Agenda Item # 4 SUB-002916-2024

Cottage Hill Meadows Subdivision

- Subdivision approval to create two (2) legal lots of record from one (1) legal lot of record and one (1) metes-and-bounds parcel, and what appears to be a portion of a vacated right-of-way.

DETAIL SITE PLAN

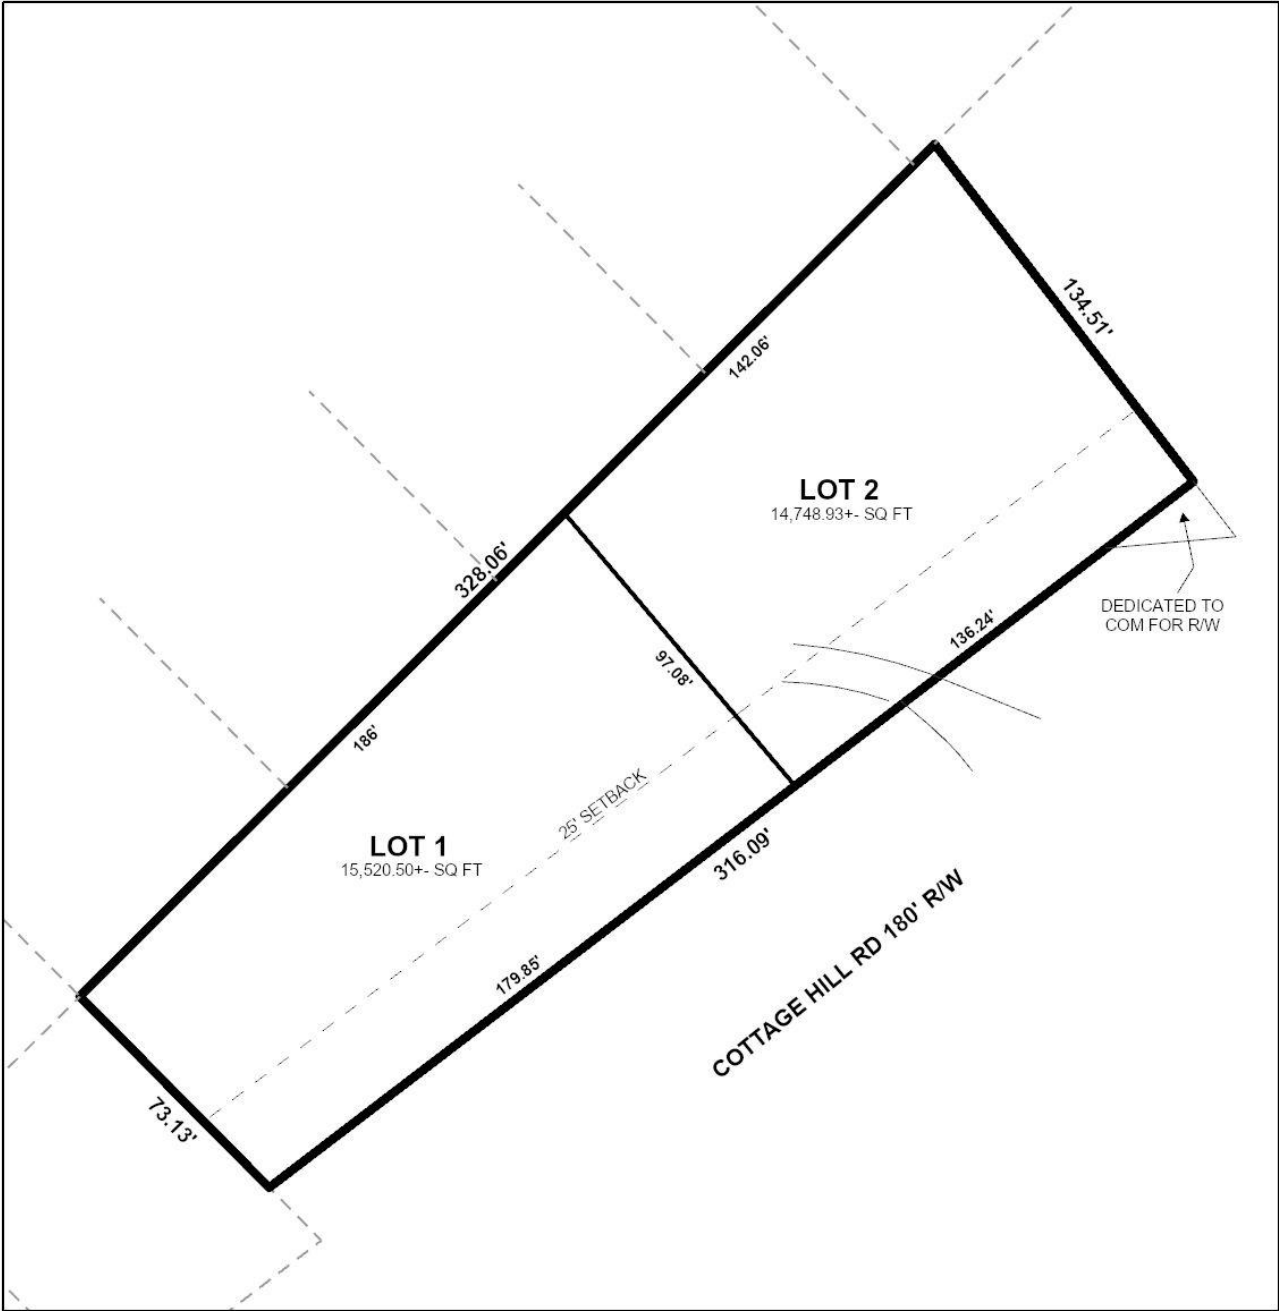
- B. Provide reference, on the map and the description, to a monumented corner.
- C. Show and label the POC and POB.
- D. Provide a correct written description for the subdivision boundary. The plan view does not show reference to Plotka Subdivision.

- E. Provide a written legal description and matching bearing and distance labels for the proposed subdivision boundary.
- F. Add a note that a Land Disturbance permit will be required for any land disturbing activity in accordance with Mobile City Code, Chapter 17, Storm Water Management and Flood Control); the City of Mobile, Alabama Flood Plain Management Plan (1984); and, the Rules For Erosion and Sedimentation Control and Storm Water Runoff Control.

Both Lot 1 and Lot 2 have frontage along Cottage Hill Road, a minor arterial road with a required 100-foot right-of-way width at this location. As illustrated, the preliminary plat depicts a 180-foot right-of-way along this section of Cottage Hill Road, and is sufficient; as such, no additional dedication should be required.

On the preliminary plat, Lot 2 depicts approximately 289± square feet of land along Cottage Hill Road to be dedicated to the City of Mobile as right-of-way. This information should be retained on the Final Plat, if approved.

The lots, as proposed, exceed the minimum size requirements for those served by public water and sanitary sewer in an R-1, Single-Family Residential Suburban District. Additionally, the lot size for both lots are labeled in both square feet and acres on the preliminary plat, as required by Section 5.A.2(e)(4) of the Subdivision Regulations. If approved, the lot sizes should be retained in both square feet and acres; or provision of a table on the Final Plat with the same information will suffice.

The preliminary plat depicts a compliant 25-foot minimum building setback line for both lots along Cottage Hill Road, in compliance with Article 2 Section 64-2-5.E. of the Unified Development Code for lots zoned R-1 in the Suburban sub-district and should be retained on the Final Plat, if approved.

1. Retention of the Lot 2 right-of-way dedication as illustrated in the preliminary plat;
2. Retention of the lot sizes in both square feet and acres, or provision of a table on the Final Plat providing the same information;
3. Retention of the 25-foot front yard setback along Cottage Hill Road for both lots, in compliance with Article 2 Section 64-2-5.E. of the Unified Development Code for lots zoned R-1 in the Suburban sub-district;
4. Compliance with all Engineering comments noted in this staff report;
5. Placement of a note on the Final Plat stating all Traffic Engineering comments noted in this staff report;
6. Compliance with all Urban Forestry comments noted in this staff report; and,
7. Compliance with all Fire Department comments noted in this staff report.
